GAS PIPELINE ON THE YUKON RIVER BRIDGE

RESPONSE TO TECHNICAL CONCERNS

DOCUMENT NO. H-17, REV. 0

1 OCTOBER 1982

MODEL OF EXISTING DIAPHRAGMS

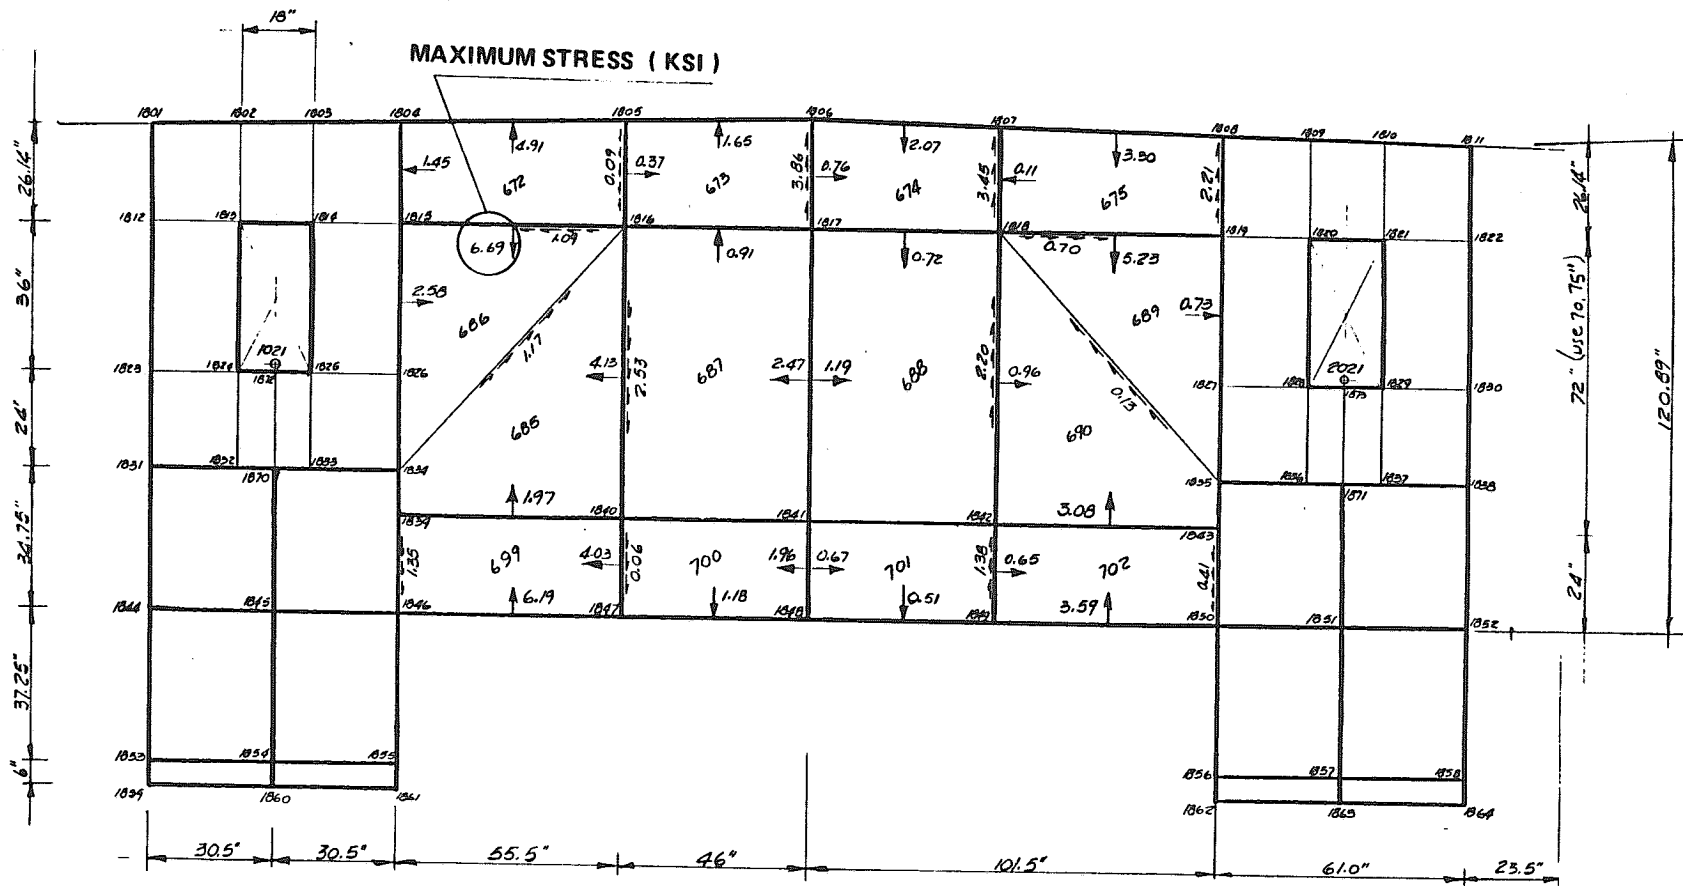
Computer stress analysis results of the existing configuration indicate that, in general, the stresses throughout the diaphragm at Pier 6 are low. The maximum stress from Group Load 1 (See Figure 2) occurs in a plate element with a value of 6.69 KSI. Analysis also indicates low stresses throughout the proposed modified diaphragm at Pier 6. The maximum stress from Group Load 2 (See Figure 3) occurs in the same plate element with a value of 7.60 KSI. The maximum stress of the modified diaphragm due to gas line installation is 14% greater than the diaphragm in the existing bridge. The stresses in both the existing diaphragm and the modified diaphragm are below AASHTO Code allowables as shown in the calculations in Appendix C.

It was determined that the modified diaphragm has a stress increase of 14 percent over the stress of the diaphragm in the existing bridge. The maximum stress of the modified diaphragm and the existing diaphragm were 7.60 Ksi and 6.69 Ksi respectively. Both of these stresses conform to AASHTO code requirements. The study centered around investigating conditions at Pier 6 since preliminary analysis indicated that the diaphragm at this pier contained the highest stresses. The conclusion can be made that the modified diaphragms at all piers will perform adequately and will meet code requirements.

HOLE IN FLANGE ON YUKON BRIDGE  
UNDEFORMED GEOMETRY PLOT

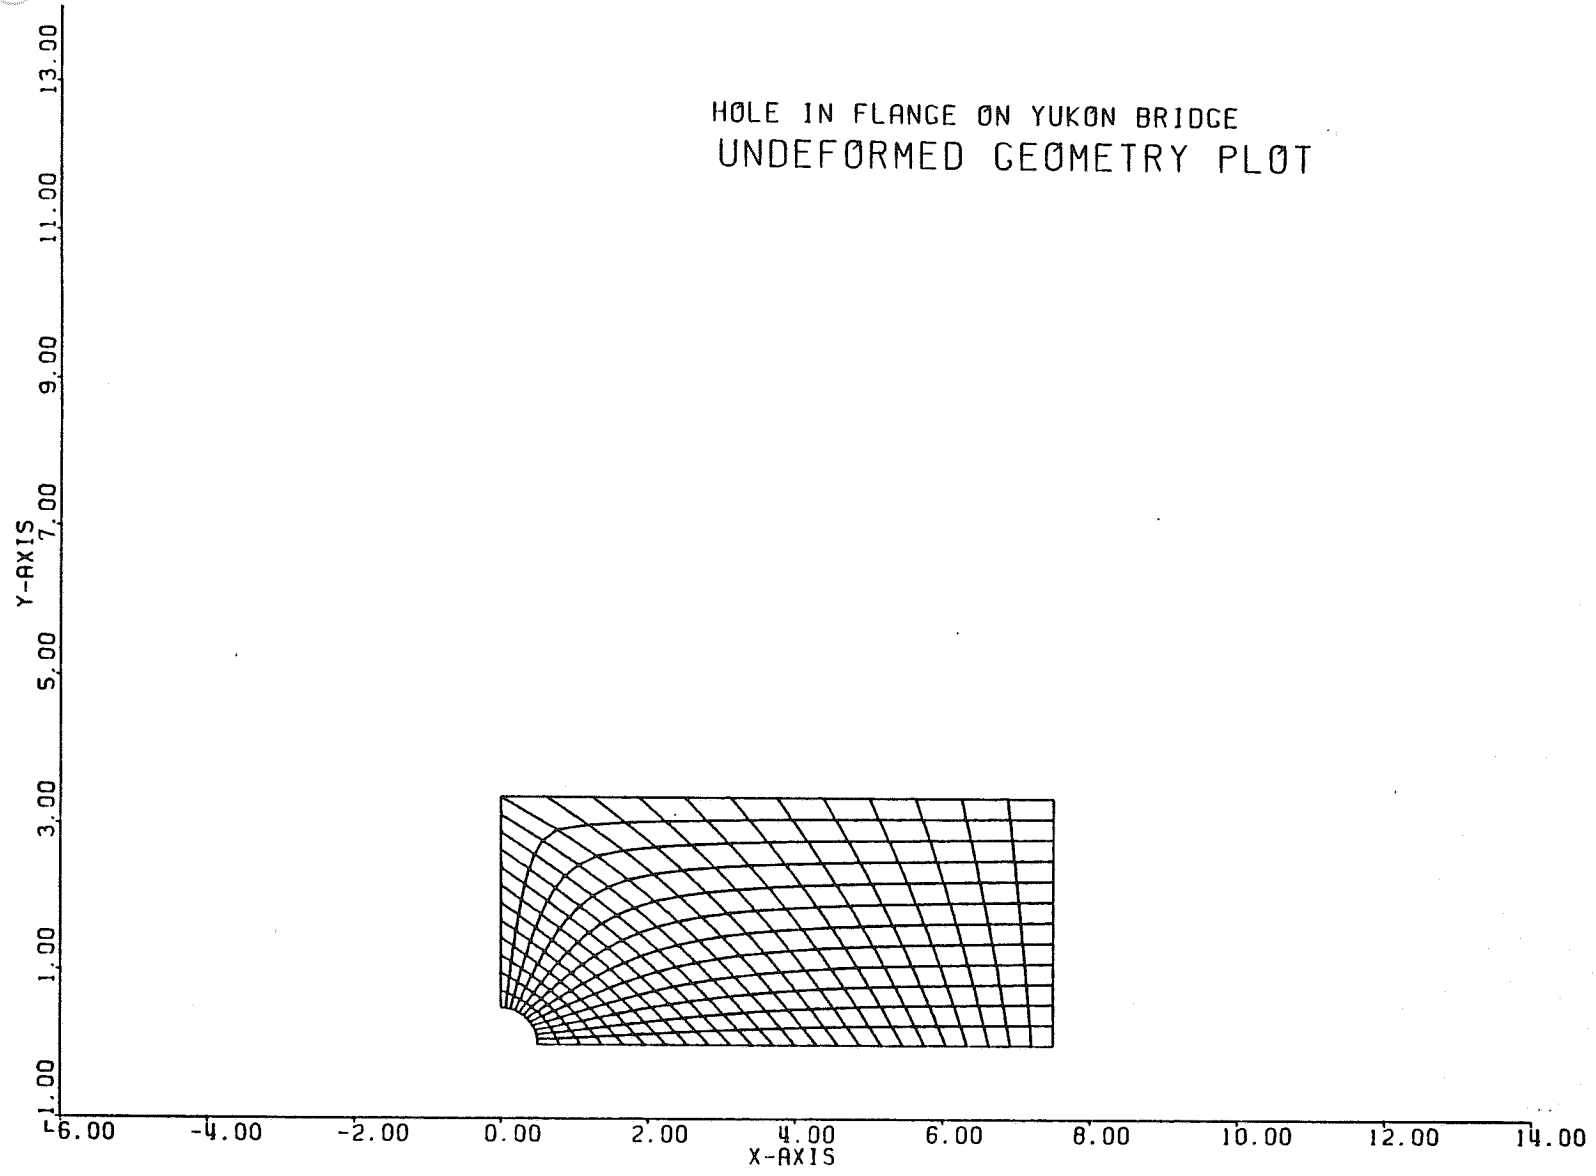
To investigate further the nature of the net section stresses and to quantify their behavior, a computer analysis using the finite element method was made. The analyses used the program PSI, developed for NWA to investigate plane strain/stress situations. The analyses features automatic mesh generation through solution of the planar Laplacian equation. The mesh generated for this analysis is shown in Figure 4 and consists of 325 nodes and 288 elements (a grid of 24x12 elements). Since the bolts to be used are 7/8 inch, the hole was sized at one inch diameter. The minimum distance between holes on the bolt line perpendicular to the longitudinal stress path is 6.75 inches. Symmetry conditions allowed the model to contain only one quarter of the bolt hole with no movement allowed in the transverse direction at the mid line and 3.375 inches from midline of the bolt hole. The longitudinal length of the model was 6.75 inches with the load applied at the extreme end. Even though the minimum distance between bolt lines perpendicular to the longitudinal stress path is three inches, the length was extended to find the distance at which the stress contours would approach those expected in the gross section. Note that no strength or extra conditions were added for the bolt itself. Thus, the condition may be thought to represent most closely the case wherein the holes are drilled, but the bolts not yet inserted. All material was assumed elastic. The thickness was input as 0.75 inches.

A detailed stress investigation was made of the local stress field around the bolt holes. The investigation specifically addressed the transient situation in which the bolt holes were made without the connection being completed. It was recognized that stress risers near the bolt holes exist but attenuate very rapidly with radial distance from the hole. However, when using very conservative assumptions, it was demonstrated that the local material around the holes would still be able to provide a significant safety factor against local failure.

4680-13-11-W-5K-064J REV. A

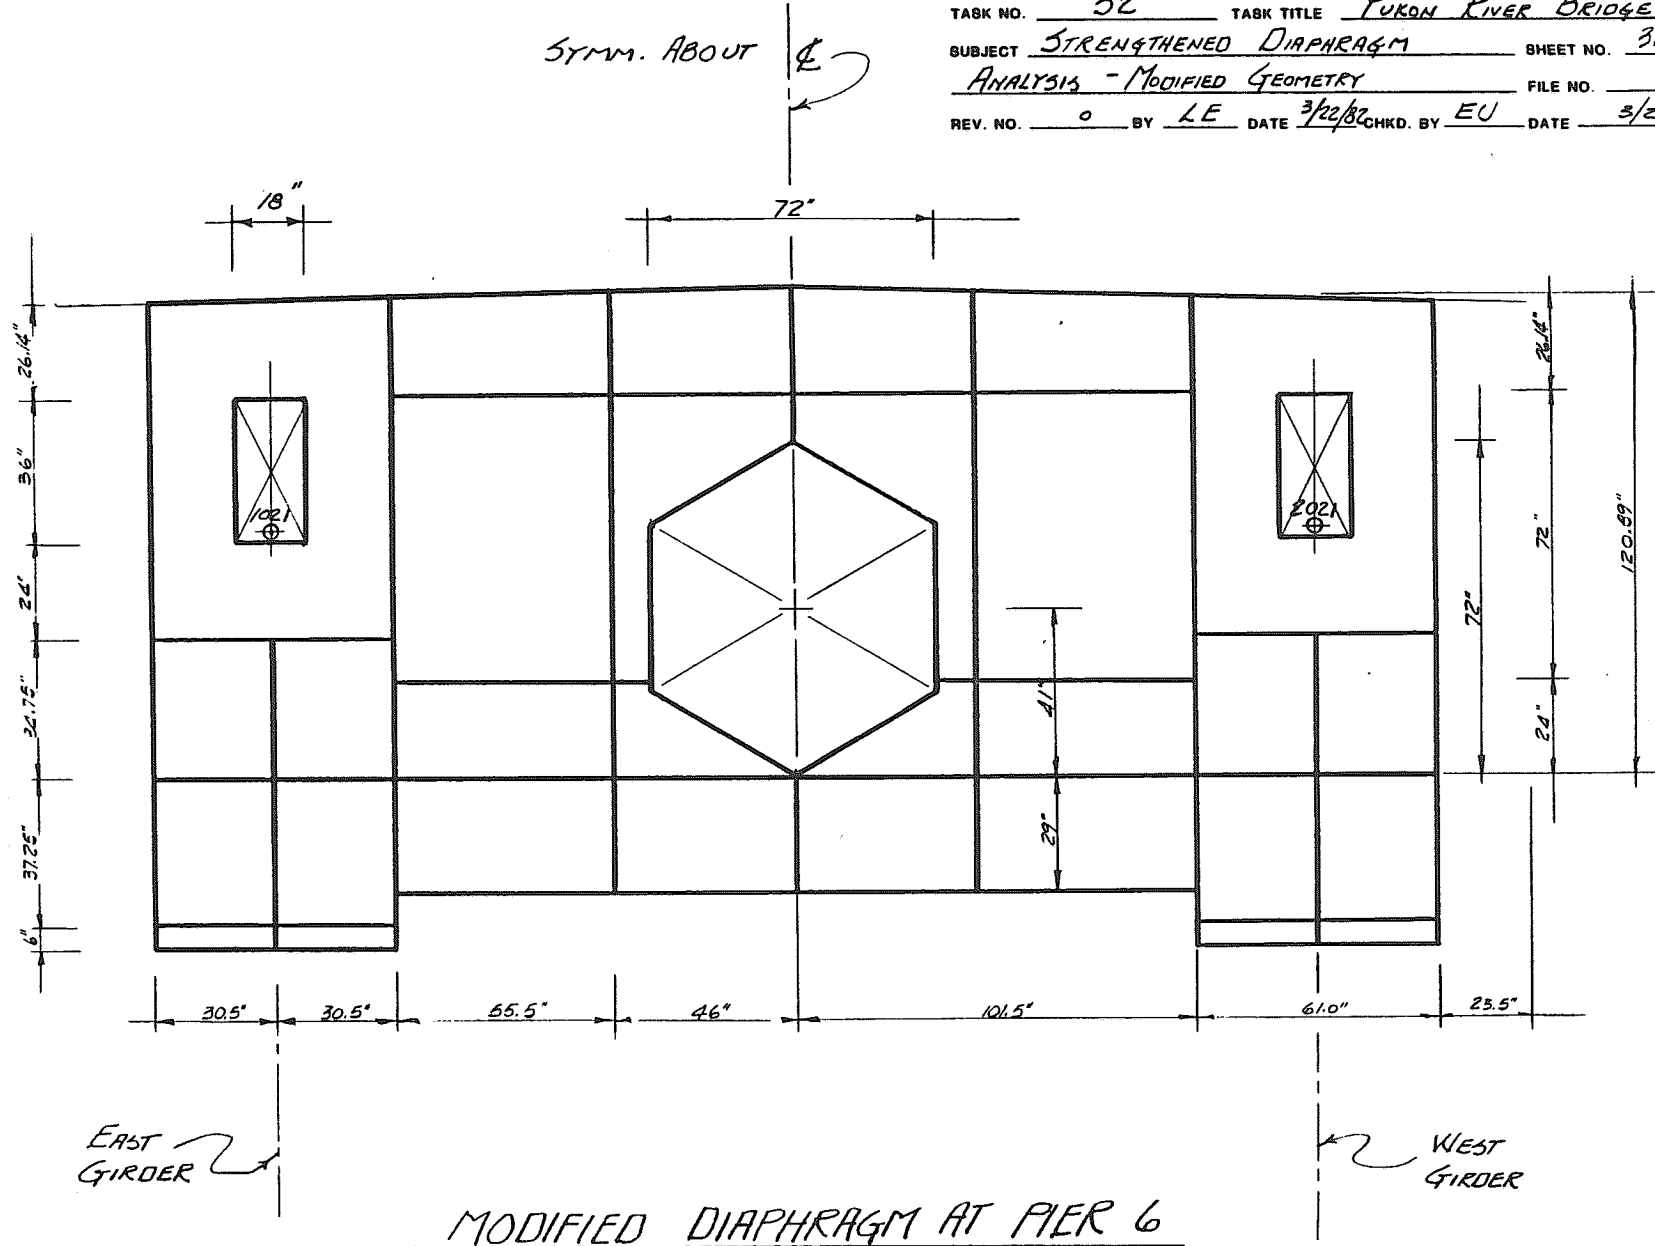
Placement of pipe under the deck would require modifications to the existing diaphragm to accommodate pipe passage at the piers and abutments. Questions were raised about the adequacy of the proposed modifications. Appendix C, Sheet 31 shows the proposed changes. A study has been performed to investigate the modified diaphragm details under erection and operating load conditions by considering a full lane load on one traffic lane. Such a loading would be expected to produce the maximum moment on the diaphragm (which provides torsional restraint).
